APPEAL SUMMARY

Status: Decision Rendered - Reconsideration of ID 15525

Appeal ID: 15735	Project Address: 329 NW Couch St
Hearing Date: 8/23/17	Appellant Name: Laurie Simpson
Case No.: B-012	Appellant Phone: 503-367-8057
Appeal Type: Building	Plans Examiner/Inspector: Marc Vieno
Project Type: commercial	Stories: 2 Occupancy: M, B, and A-2 Construction Type: III-B
Building/Business Name: FORTUNE	Fire Sprinklers: Yes - fortune tenant space
Appeal Involves: Alteration of an existing structure, Reconsideration of appeal, occ Change from B to A-2	LUR or Permit Application No.: 17-221403--CO
Plan Submitted Option: pdf [File 1] [File 2] [File 3] [File 4] [File 5]	Proposed use: RESTARAUNT

SECTION 1

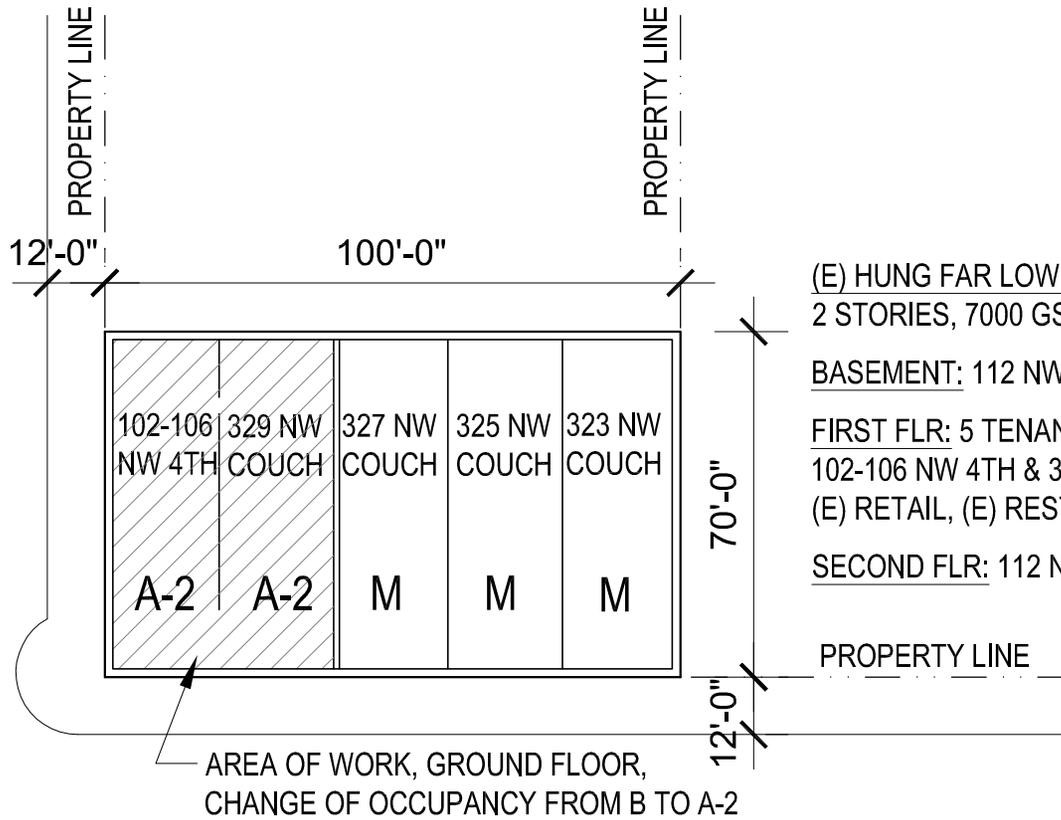
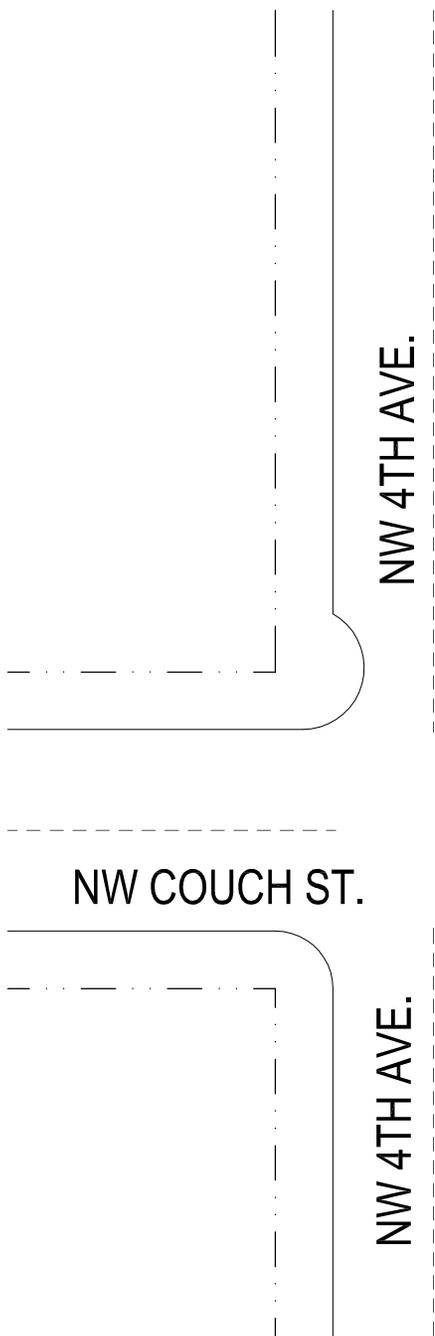
The beams and girders that support the second floor, however, are robust heavy timber (see attached) and will survive 2 hours of fire. Increasing the density of the sprinkler heads provides further protection. The fire resistance rating of the east/west wood beams is 144 minutes (2 each at 18 1/2" deep and 9 1/2" wide. gross width is 19" = 144 minutes (Z=1.0)). The fire resistance rating of the North/South Beams = 119 minutes (16" deep and 115 1/2" wide = 119 minutes (Z=1.0)). In addition, the posts are 16" x 16", the exterior walls are 12" solid reinforced concrete, and the concrete piers are 2'-6" x 12" reinforced concrete.

The demising wall is further protected with sprinkler heads that are spaced closer together. Refer to attached drawing of existing assemblies. A copy of the original blueprints (from microfiche) are available upon request.

Reconsideration Extension of approved time frame for full sprinklering of building granted in appeal #15225: Denied. Proposal does not provide equivalent Fire / Life Safety protection.
